7.0 Instrumentation and Control Systems

The information in this section of the reference ABWR DCD, including all subsections and tables, and figures, is incorporated by reference with the following departures and supplements.

Figure 7.0-1 SSLC Self-Test System

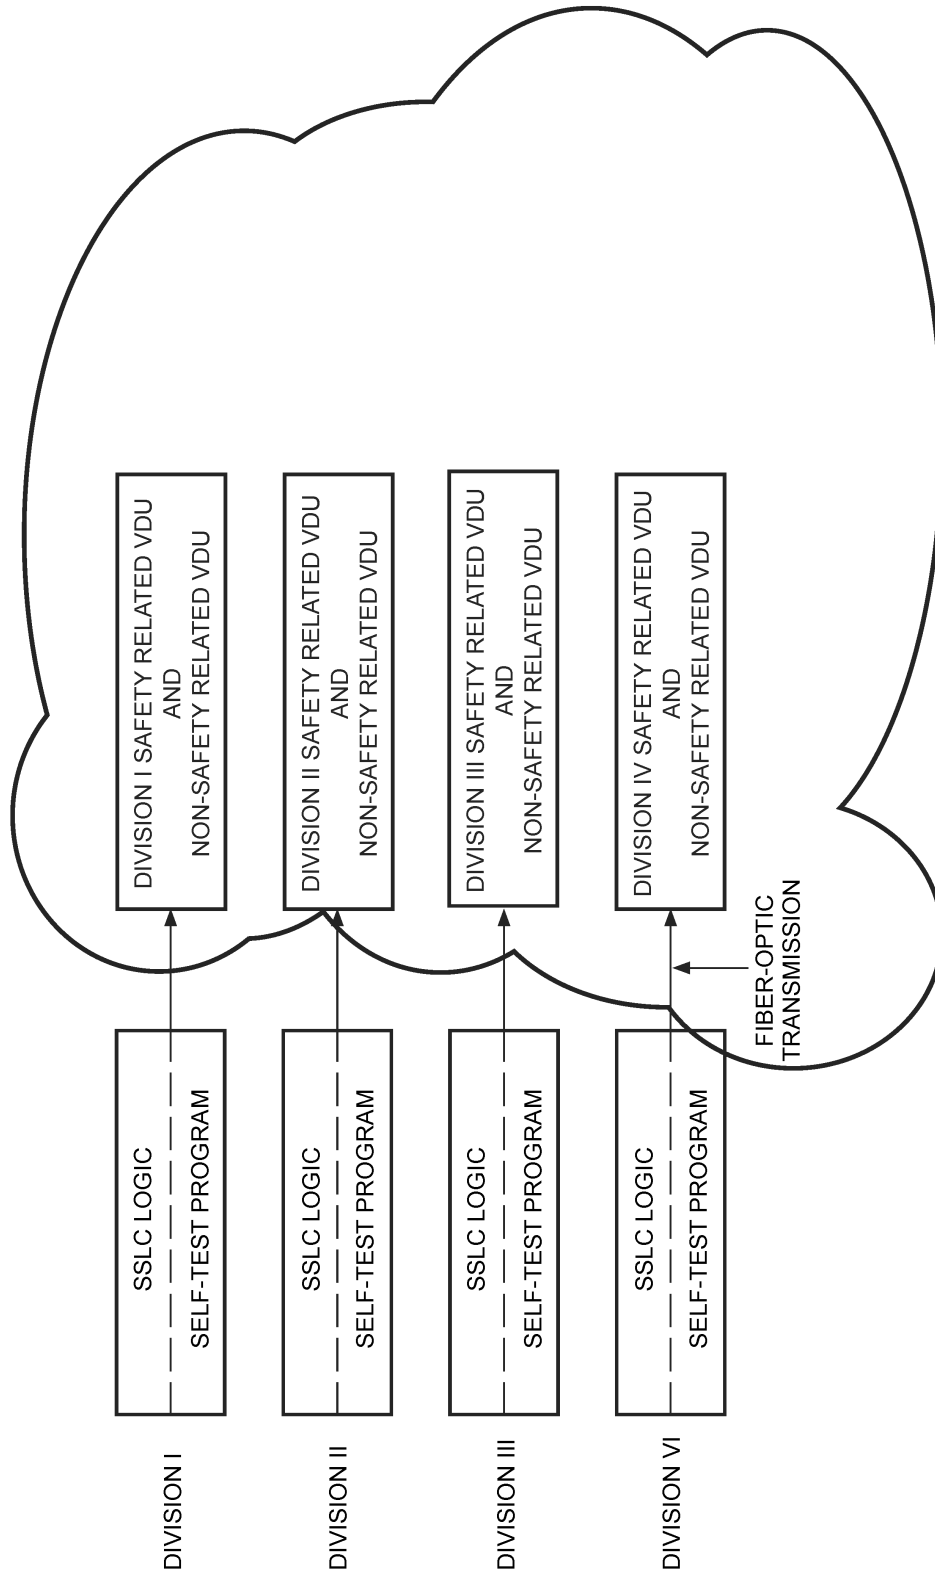
The ~~Essential Multiplexing System (EMS)~~ Essential Communication Function (ECF) is included in the continuous, automatic self-test function. Faults at the ~~Remote Multiplexing Units (RMUs)~~ Remote Digital Logic Controllers (RDLs) are alarmed in the main control room. Since the ~~EMS ECF~~ ECF is dual in each division, self-test supports automatic reconfiguration or bypass of portions of ~~EMS ECF~~ ECF after a detected fault, such that the least effect on system availability occurs.

To reduce operator burden and decrease outage time, a surveillance test controller (STC) is provided as a dedicated instrument in each division of ~~SSLG~~ ELCS. The STC performs semi-automatic (operator-initiated) testing of ~~SSLG~~ ELCS functional logic, including trip, initiation, and interlock logic. Test coverage includes verification of correct operation of the following capabilities, as defined in each system IBD:

- (i) Each 2/4 coincident logic function.
- (ii) Serial and parallel I/O, including manual control switches, limit switches, and other contact closures.
- ~~(iii) The 1/N trip selection function.~~
- ~~(iv)~~ (iii) Interlock logic for each valve or pump.

The STC injects test patterns through the ~~EMS~~ Essential Communication Function (ECF) of the ELCS communications links to the ~~RMUs~~ RDLs. It then tests the ~~RMUs~~ "RDLs" ability to format and transmit sensor data through and across the ~~EMS/SSLG~~ ECF of the ELCS interface, in the prescribed time, to the load drivers. Under the
